Subject: Partial Response to Environmental Protection Agency (EPA) May 20, 2004 Letter on CRA

Table 1 Summary Schedule for DOE Responses to EPA's First CRA Information Requests

Figure 1. **CRA PA and CCA PAVT Spallings Release Means, All Replicates Pooled**

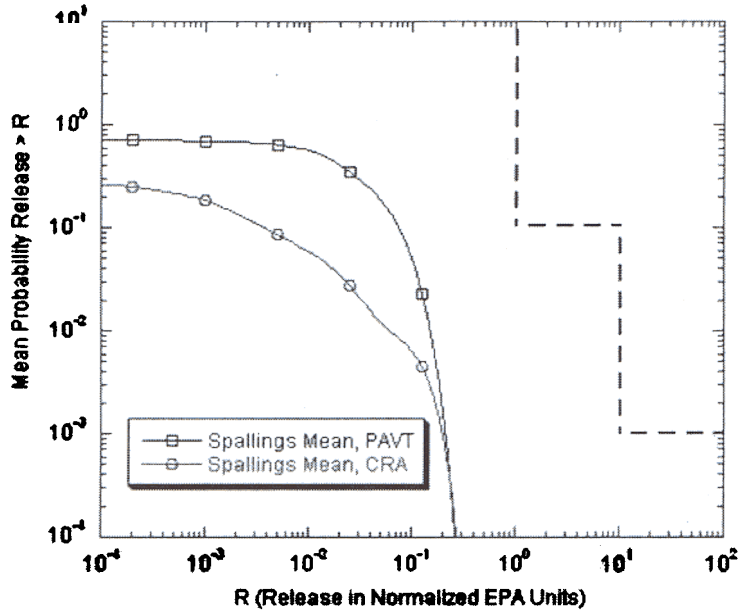
The previous baseline for DOE's compliance (from the initial certification decision completed in 1998) is the Performance Assessment Verification Test (PAVT) set of CCDFs and releases at the regulatory limits. To provide context for understanding the changes from the previous baseline, DOE must provide a comparison of the CCA PAVT results to the results of the CRA PA in a tabular form with columns/rows for 0.1 and 0.001 probabilities. For the table, use as an example the table submitted as part of the review of super compacted waste (Comparison of AMW and PAVT Results with CRA Results by C.W. Hansen, March 19, 2004. ERMS 534241 and EPA Docket A-98-49, Item II-B2-34).

The CRA PA releases at probabilities of 0.1 are smaller than the CCA PAVT releases at the same probabilities due to a decreased contribution of spall. The typical spall release in the CRA PA at a probability of 0.1 is smaller than the typical spall release in the PAVT CCA at the same probability (Figure 1).

Figure 1: Disturbed Rock Zone around a Raised Disposal Room in the Absence of Gas Generation (Park and Holland, 2003).

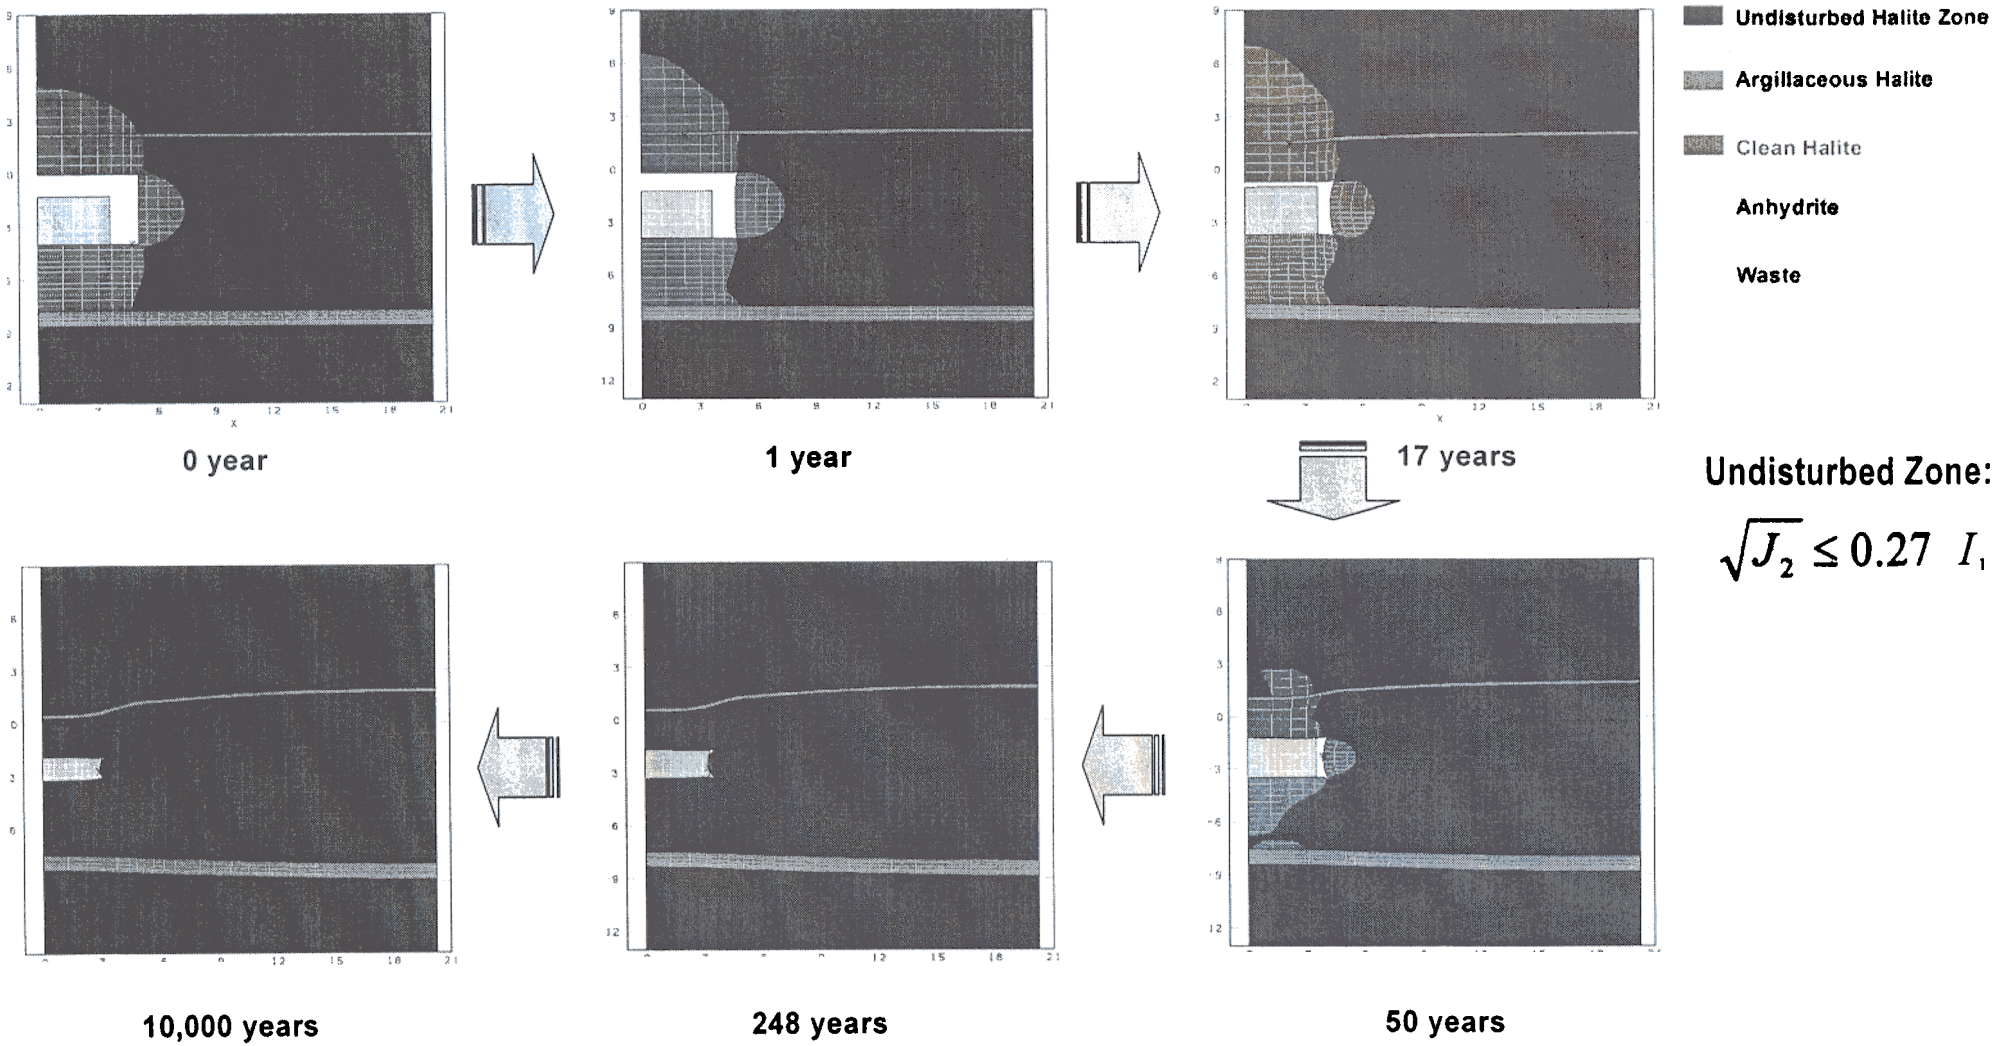
The CRA states that the "DRZ would not reach MB 138." DOE must supply documentation to justify this assertion.

Details of the Clay G analyses also provided insight to the local behavior of the DRZ evolution and devolution and the distortion of the anhydrite layers near the disposal rooms. An example of DRZ calculations is shown in Figure 1. These calculations at the raised horizon invoke principles of damage and healing as discussed by Hansen (2003). For the raised repository, the DRZ does not penetrate Marker Bed 139. The DRZ did penetrate Marker Bed 139 for the original horizon condition. The DRZ extends to its greatest dimensions in the period before the surrounding salt makes contact with the waste. Based on the modeling results, the maximal extent of the DRZ above the rooms is 6.5 m. The distance to MB 138 is 12 m and 9.5 m for the normal repository horizon and the elevated horizon, respectively.

Between 10 and 20 years, the creeping salt will begin pushing against the waste stack, a condition that decreases the driving stress difference. Shortly thereafter the stresses in the salt transcend from damaging to healing conditions. There is no time dependency applied to the healing process, because empirical evidence shows that healing would be rapid and the DRZ would diminish as depicted in Figure 1.

Thus, the geophysical testing and modeling results show that the DRZ is limited in extent and heals as the salt compresses the waste. Therefore, the DRZ would not reach MB 138.
